COMMUNITY SERVICES DEPARTMENT

Subject: Cloverleaf Subdivision Preliminary Plan, Review #4 (SP-20-002)

Cloverleaf Subdivision Preliminary Plan Review

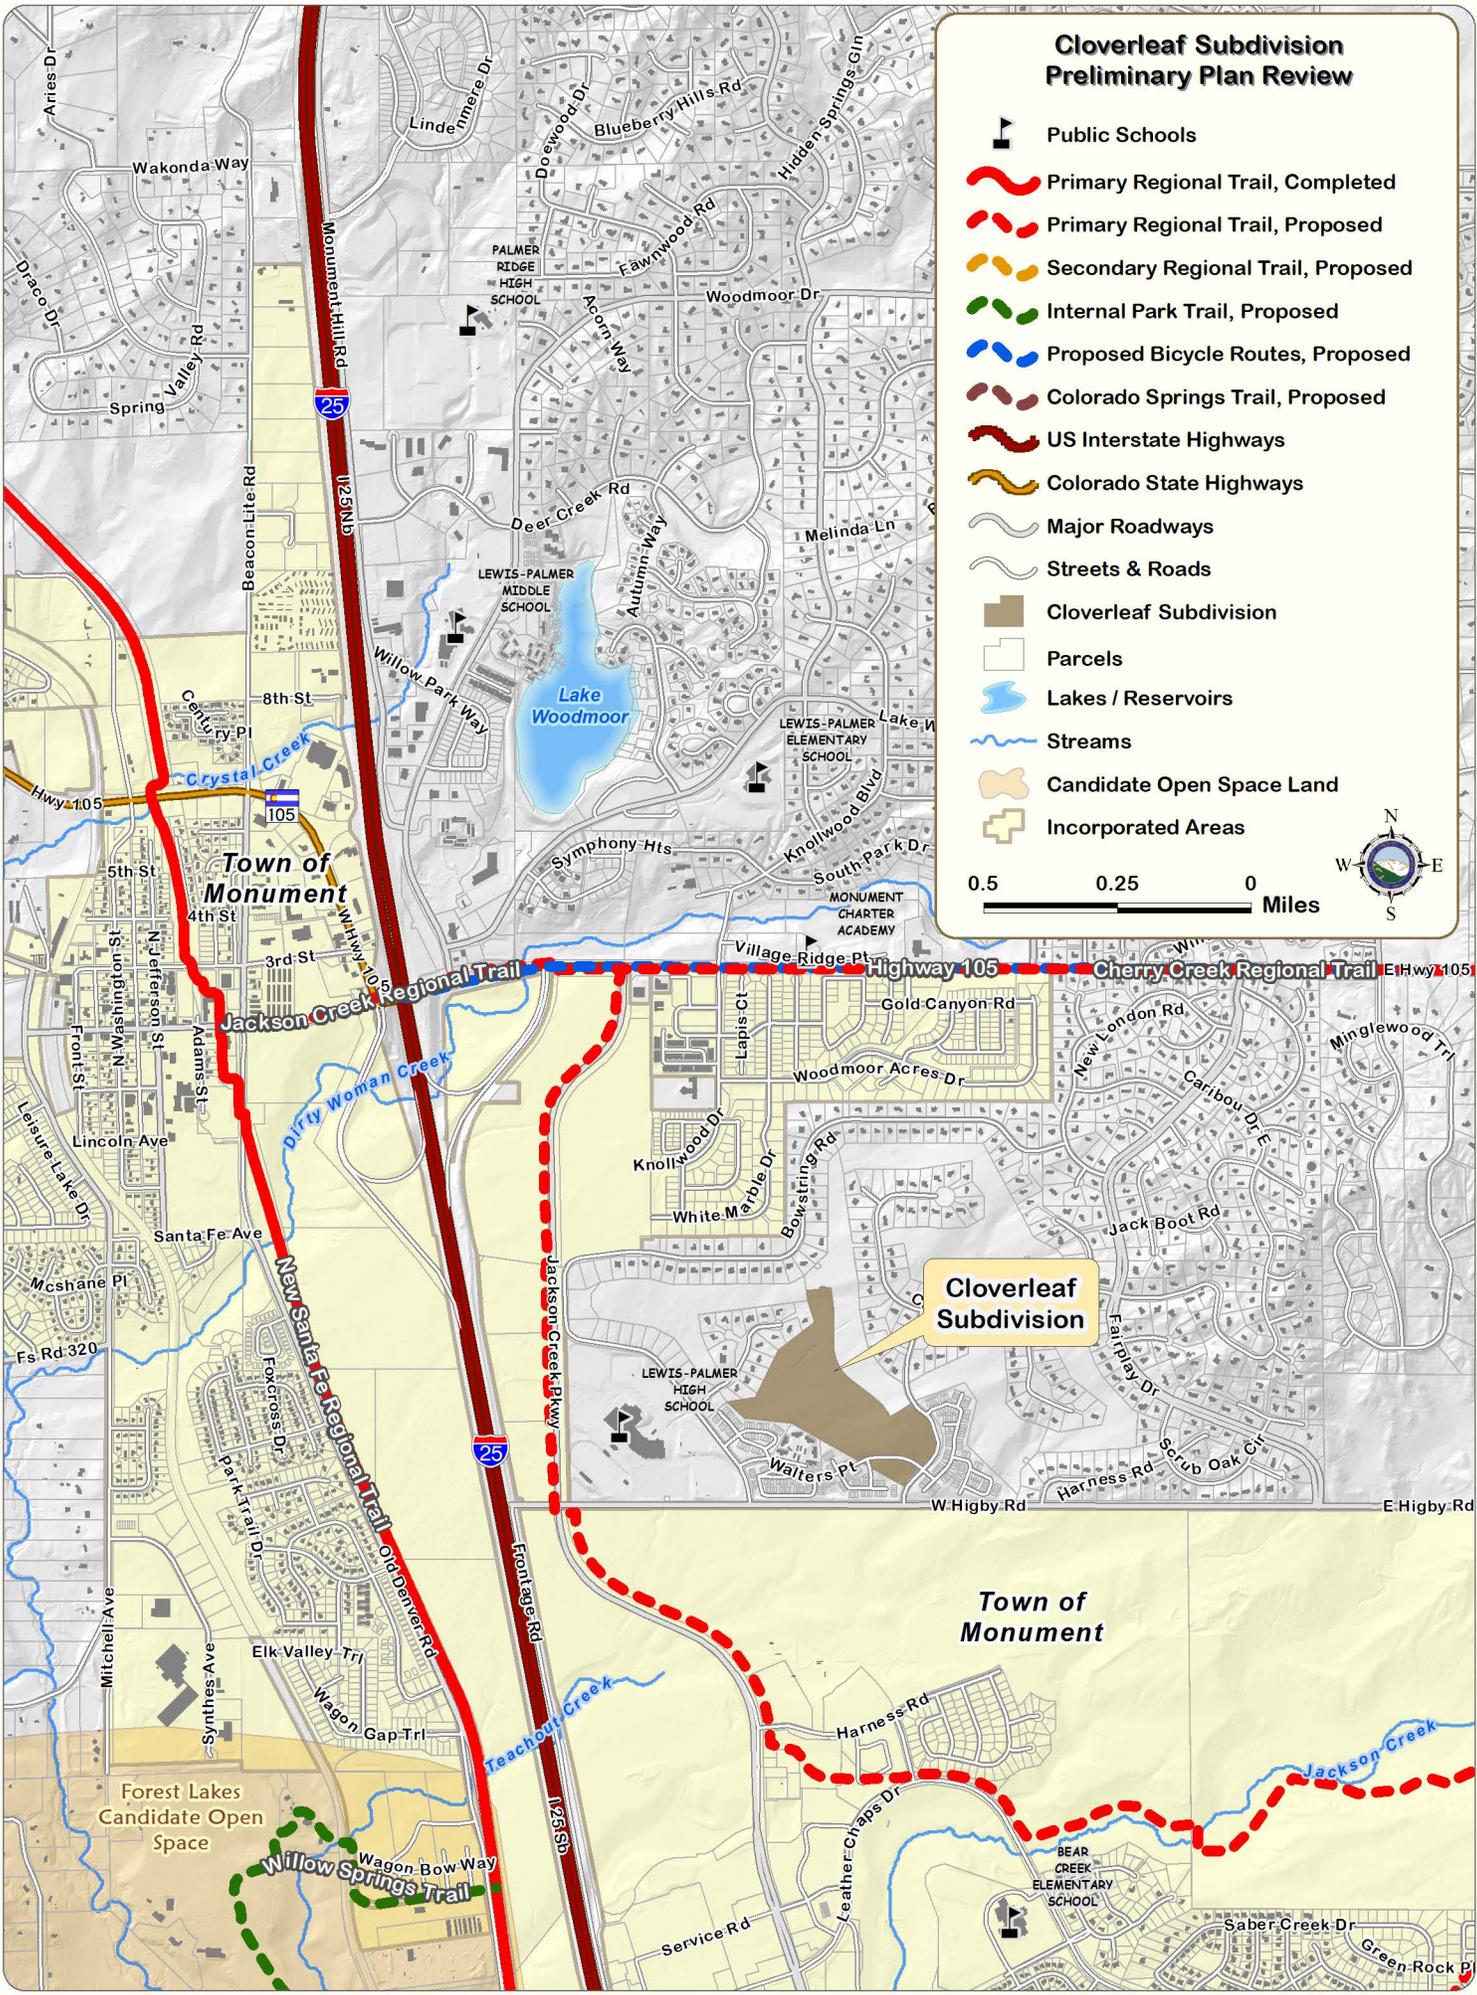
The Park Operations Division of the Community Services Department has reviewed the Cloverleaf Subdivision Preliminary Plan development application, Review #4, and has additional comments of behalf of El Paso County Parks. El Paso County Parks is disappointed to see the removal of the local walking path located behind the lots on Crimson Clover Drive. Staff understands that the removal was in response to comments submitted by residents of Leggins Way, located adjacent and northwest of the Cloverleaf subdivision. The loss of this trail reduces access for residents on the northern side of the development to points on the southwest side, such as Lewis-Palmer High School. Staff recommends that the applicant restore this trail to allow for safe off-street pedestrian access through the development. Post and dowel fencing could be installed along the trail to provide an attractive deterrent to unauthorized entry of the residential lots along Leggins Way.

The 2013 El Paso County Parks Master Plan shows no regional trails running through or directly adjacent to the proposed subdivision. The proposed Jackson Creek Regional Trail is located 0.35 mile to the east of the project site, while the Cherry Creek Regional Trail and Highway 105 Bicycle Route are both located 0.60 mile north of the property. The existing New Santa Fe Regional Trail is located 0.75 mile to the west of the property. Cloverleaf Subdivision does not lie within any candidate open space area.
